CITY OF ALBUQUERQUE

RE: 9050 Alameda Blvd NE
Grading and Drainage Plan Stamp Date: 2/20/19
Drainage Report Stamp Date: 2/20/19
Hydrology File: C20D077

DRAINAGE REPORT
FOR
LOT 16, BLOCK 4, TRACT 3, UNIT 3
NORTH ALBUQUERQUE ACRES

1776 Montano Blvd. NW, SUITE 24
LOS RANCHOS DE ALBUQUERQUE, NEW MEXICO 87107

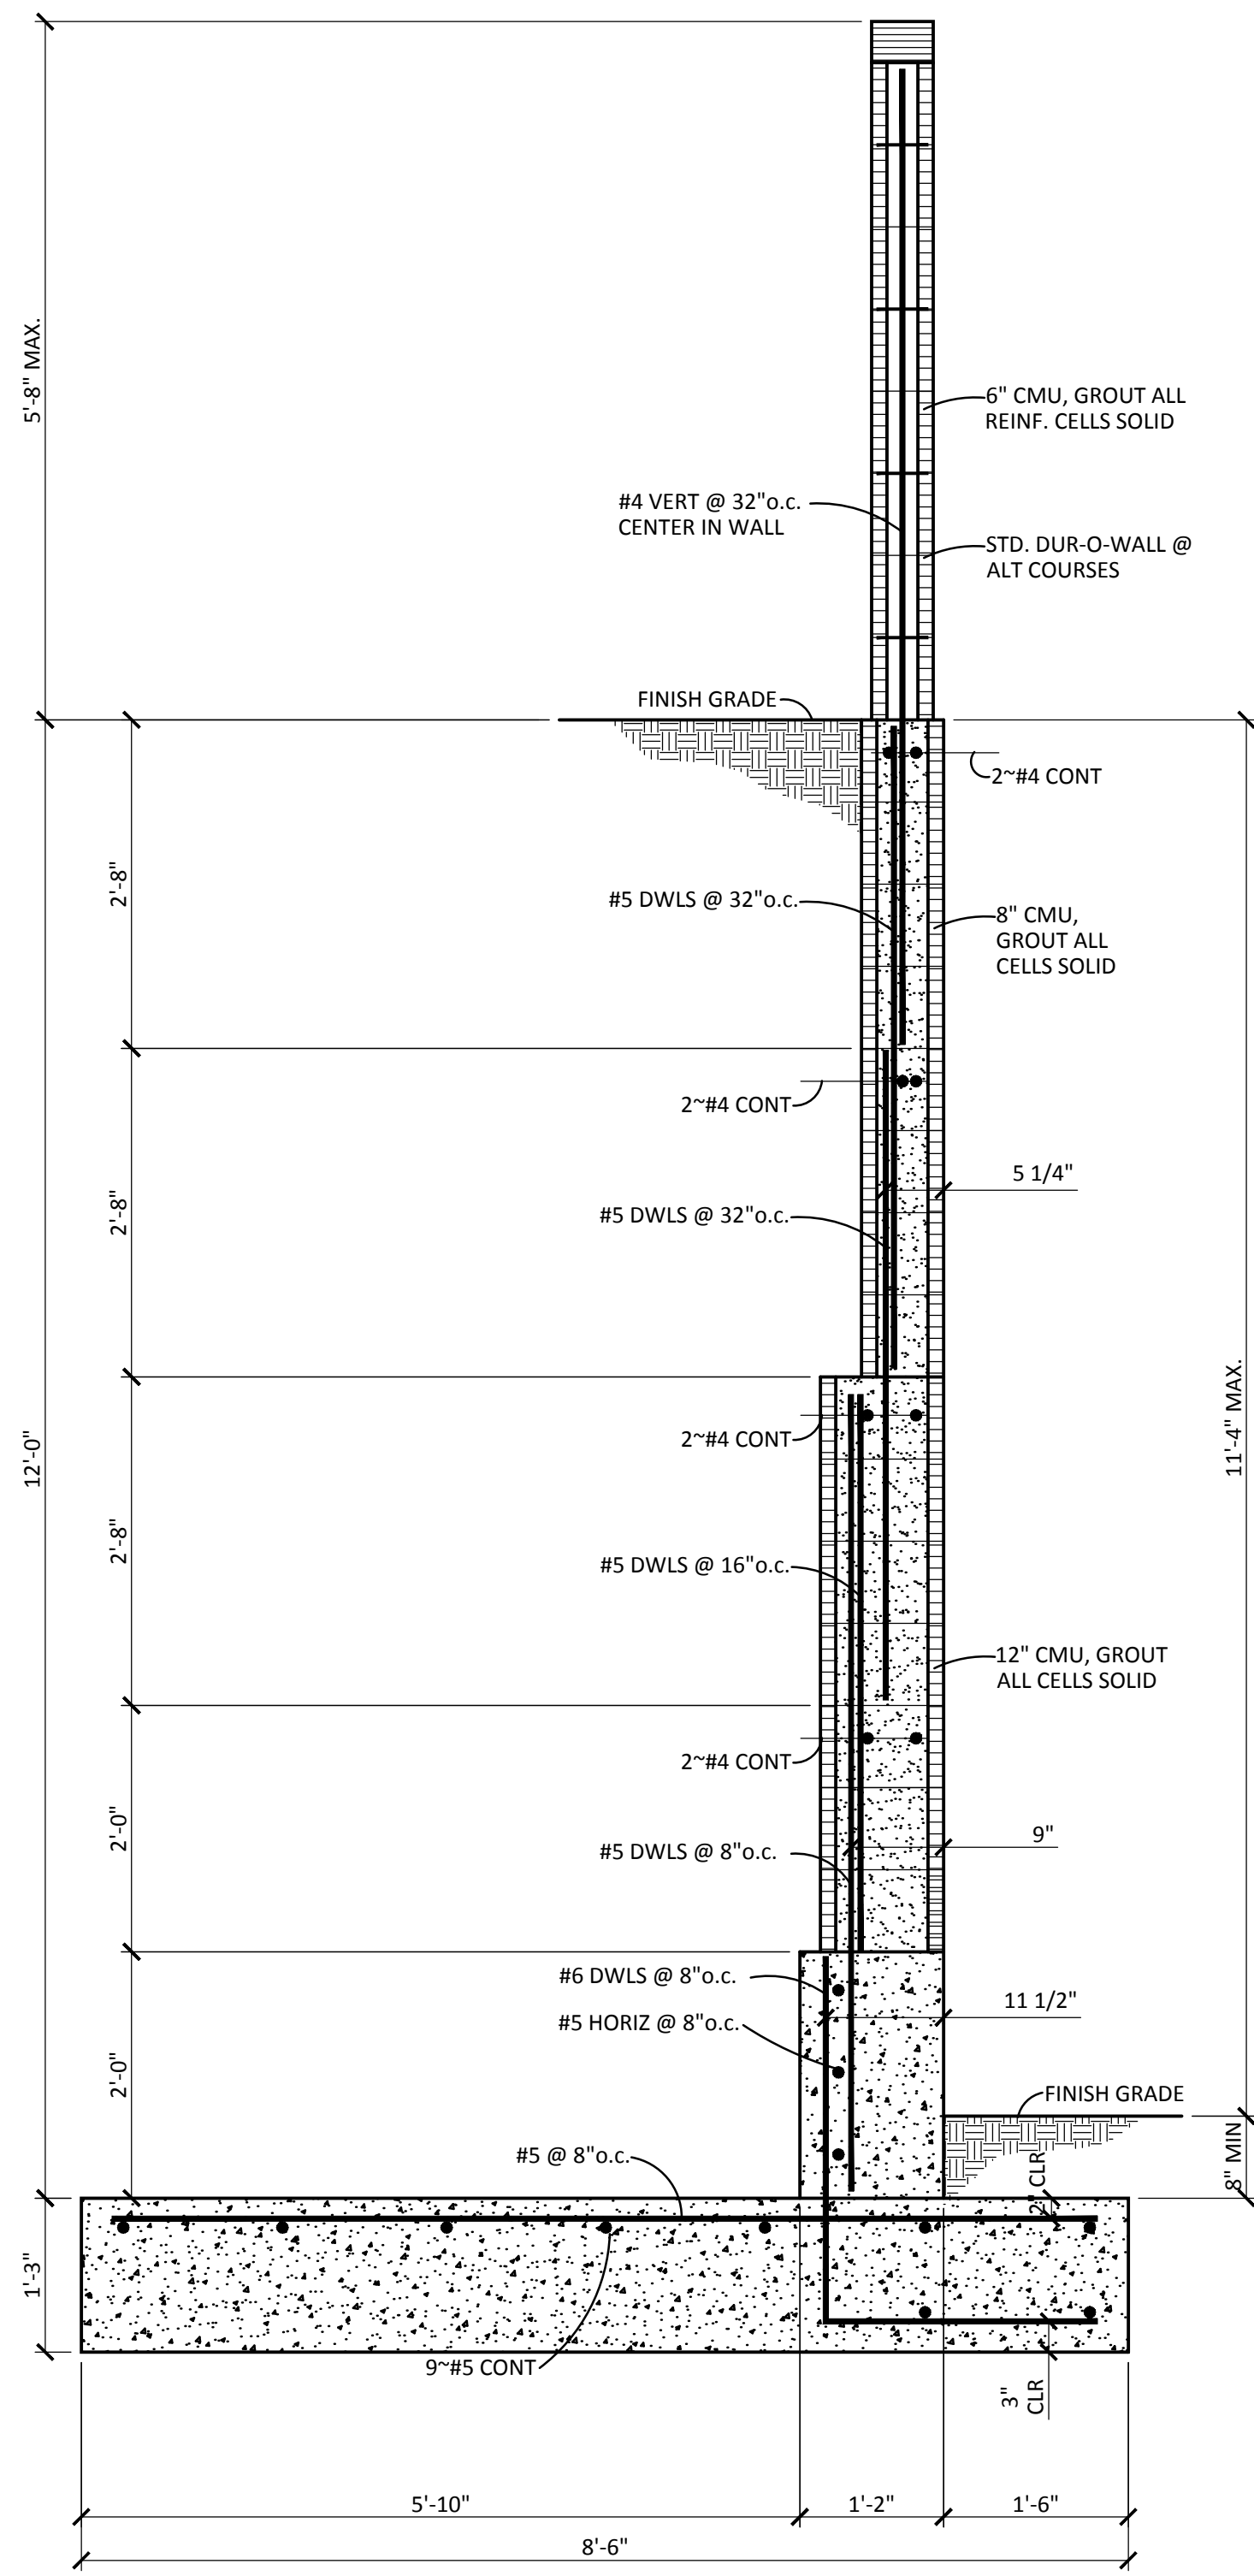
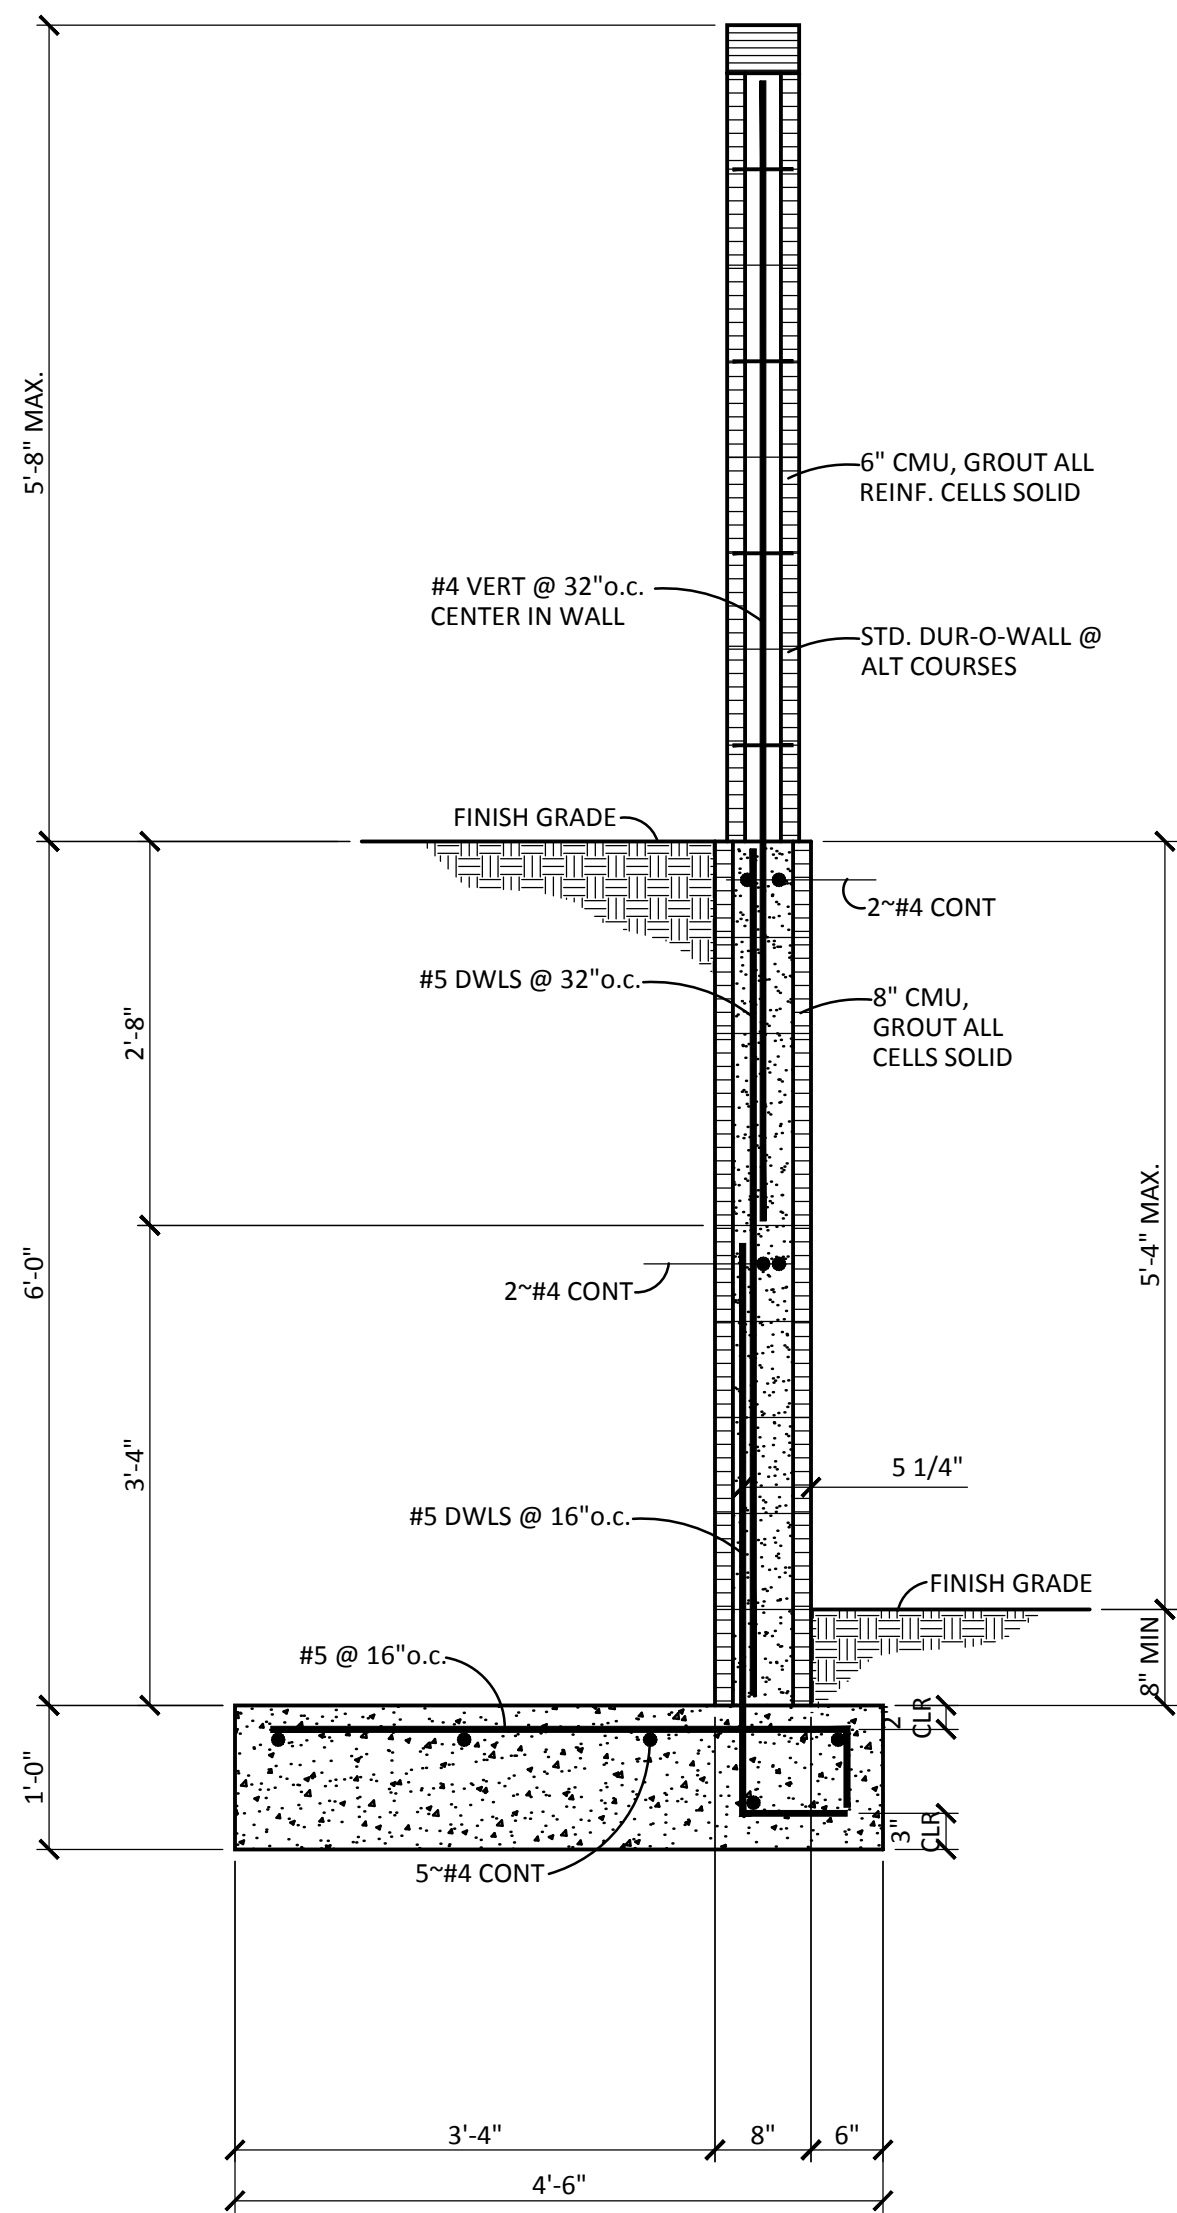
- a. The footing of the scour wall looks too small. The footer has to support the wall after the soil is removed from the low side to the scour depth. Please provide structural calculations including loading assumptions stamped by a registered professional engineer to accompany the wall details shown on the G&D sheets.

- b. The retaining wall details on sheets S1 and S2 don't contain the information requested in this comment, specifically the easement and property lines. There is also no indication where each section applies.
